CONSTRUCTION PLANS FOR:

**OWL MARKETPLACE**  
 EL PASO COUNTY, COLORADO

**GENERAL NOTES & ROAD CROSS SECTIONS**

**Know what's below. Call before you dig.**  
 CALL 2-BUSINESS DAYS IN ADVANCE BEFORE YOU DIG, GRADE, OR EXCAVATE FOR THE MARKING OF UNDERGROUND MEMBER UTILITIES.  
 PCD FILE: VR2321

**STILLING BASIN DETAIL**  
SCALE: 1"=5'

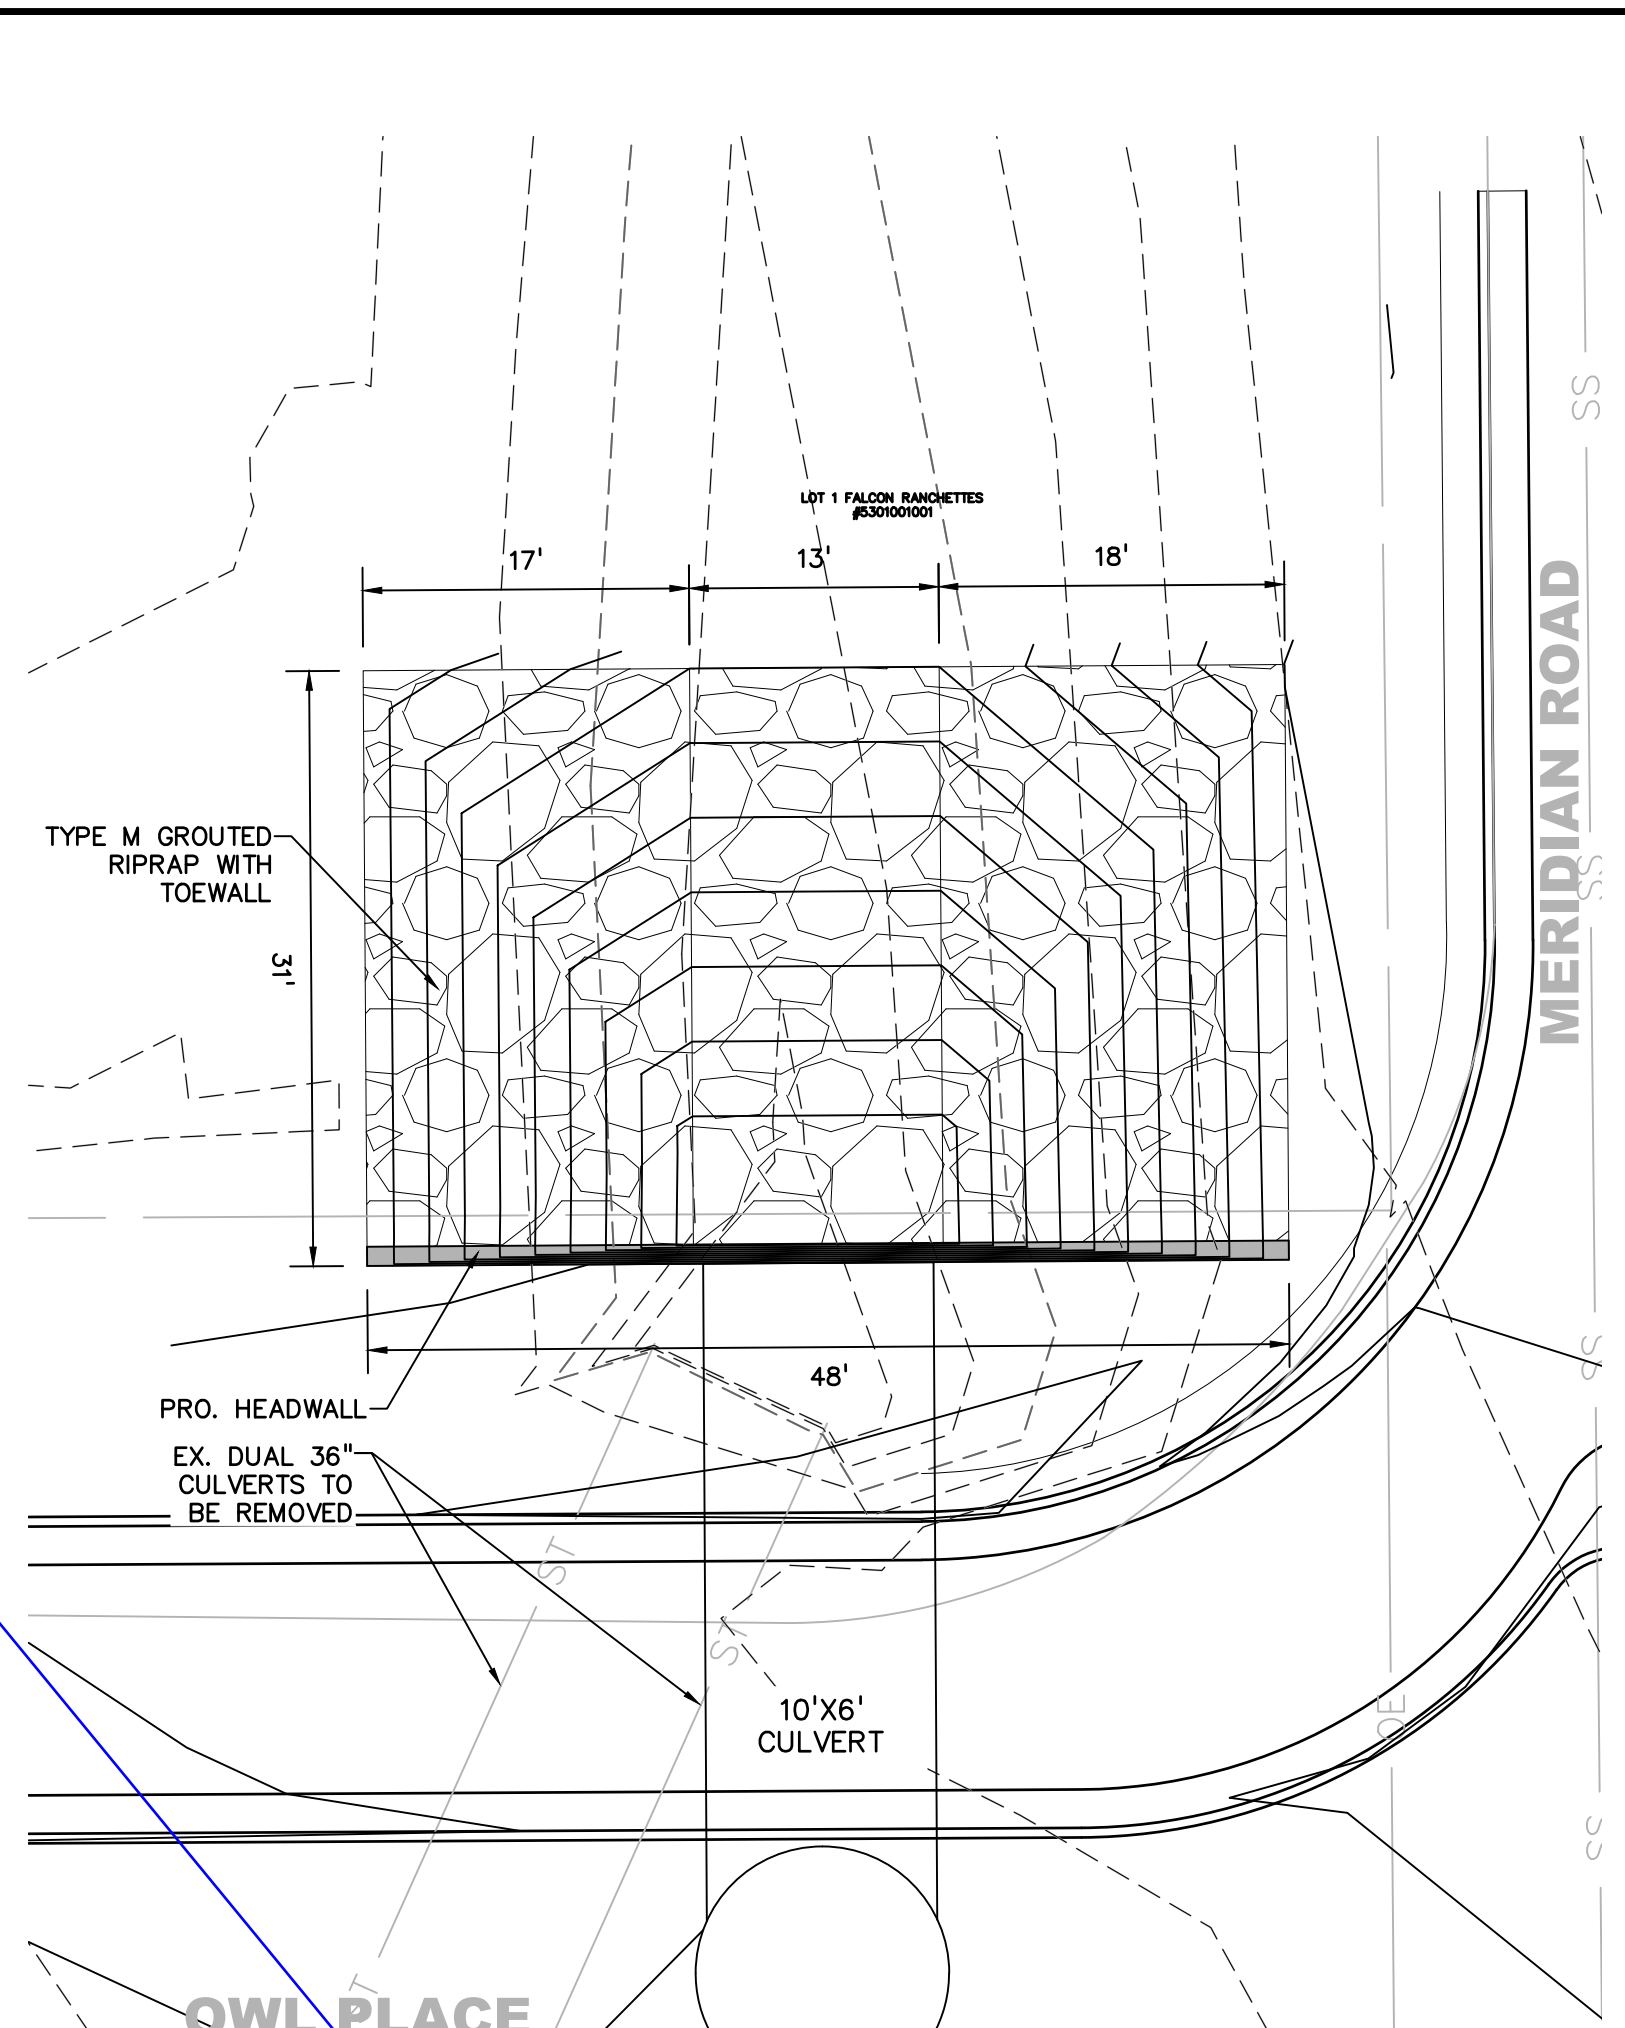
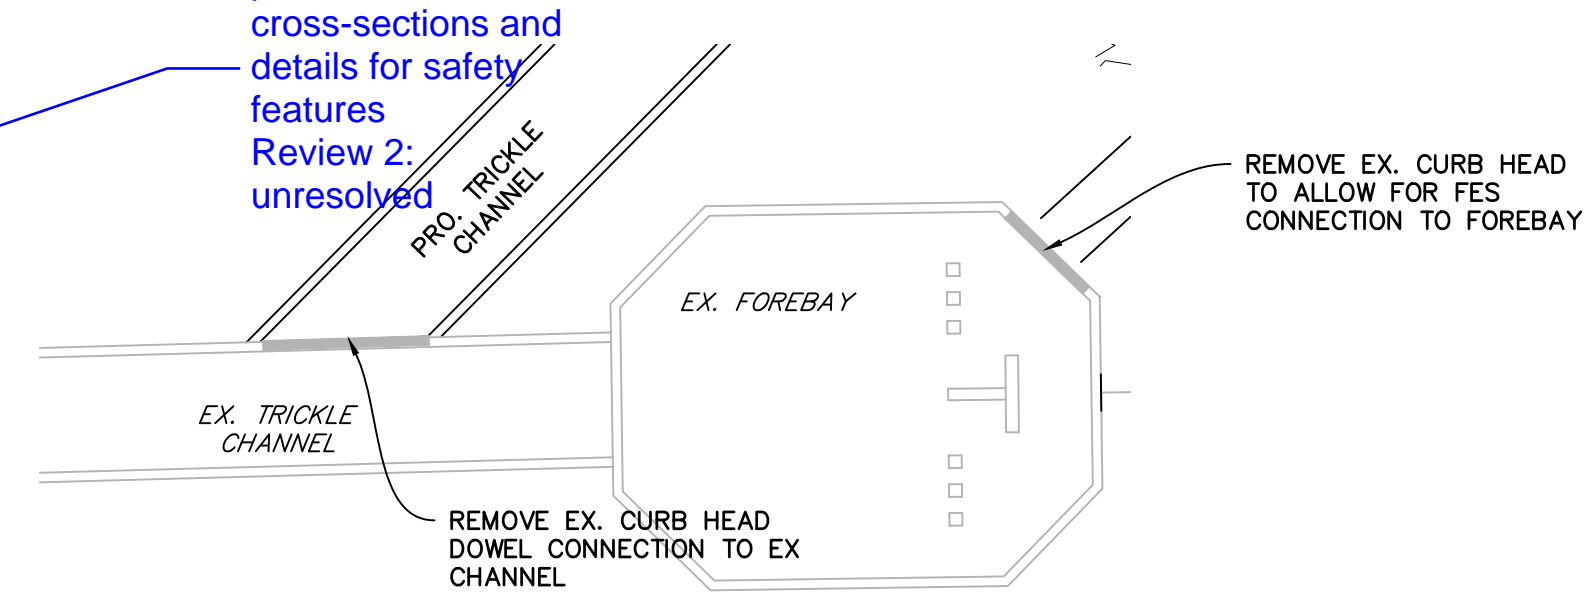
PDF page 54 of the FDR shows that a weir length of 46in is needed here.

Review 1: Provide profile cross-sections and details for safety features  
Review 2: unresolved

review 1: show connections of the proposed 30" storm pipe and provide energy dissipation at this new connection. provide details.  
Review 2: Unresolved.
